BEFORE THE STATE OF NEVADA,
STATE ENVIRONMENTAL COMMISSION

Appeal of Solid Waste Disposal Site Permit

Permit No. SW495REV00

APPELLANT BRIEF OF RICHARD COOK

Exhibit A 3/19/12 photo of proposed site facing south from near Jungo Rd. Lat. 40.927N Long. 118.3004W.

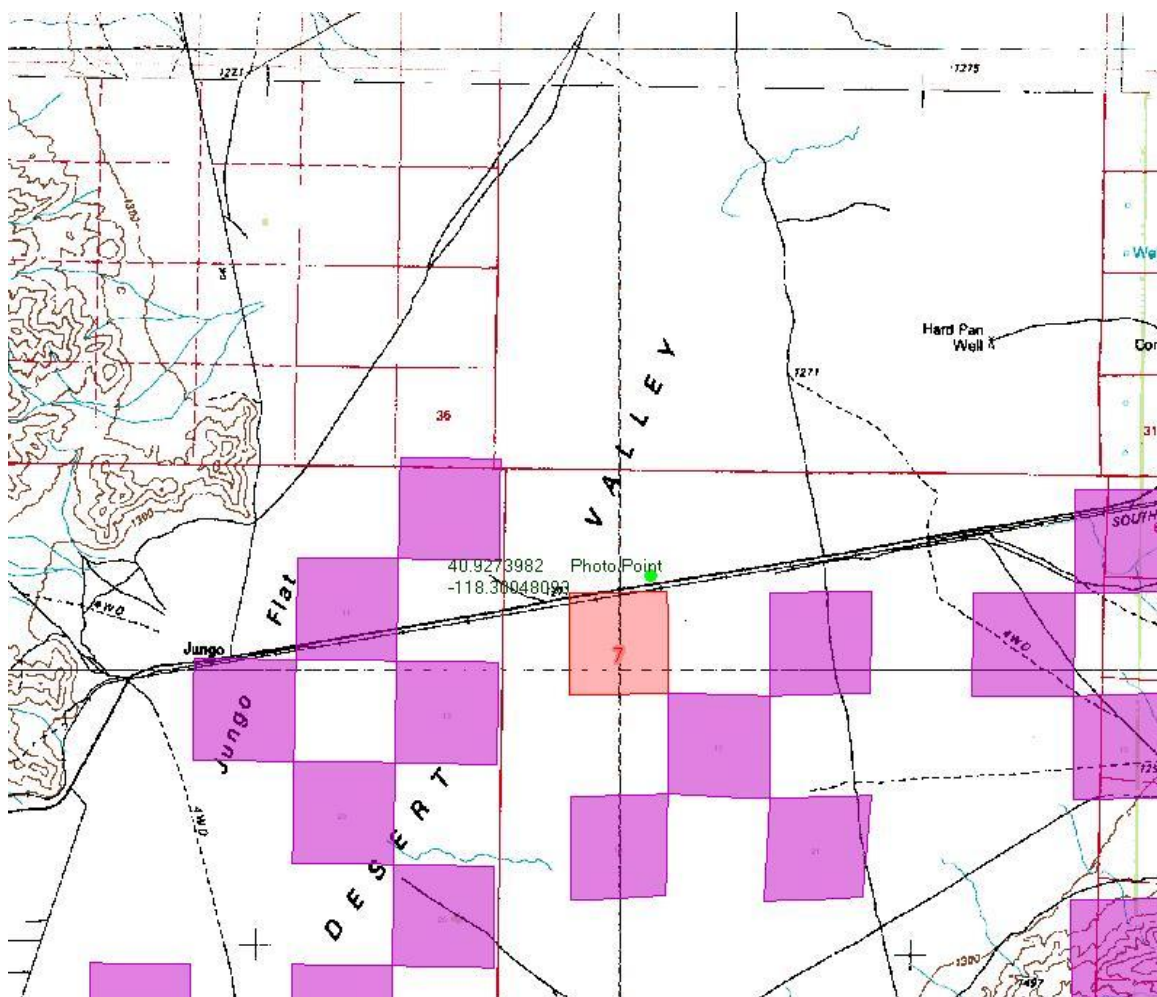
Recology's NDEP approved plan to build a 4' high berm of native soils around the site to control run-on and run-off would only result in a berm that has water on both sides and the site will still be impassable. Planned drainage ditches won't work as there is nowhere for water from the site to be drained to. Frequently during winter and spring months the landfill operator will be forced to pile waste indefinitely on the railroad siding landing with no way to move it to an active landfill cell. **(Exhibit A and B)**
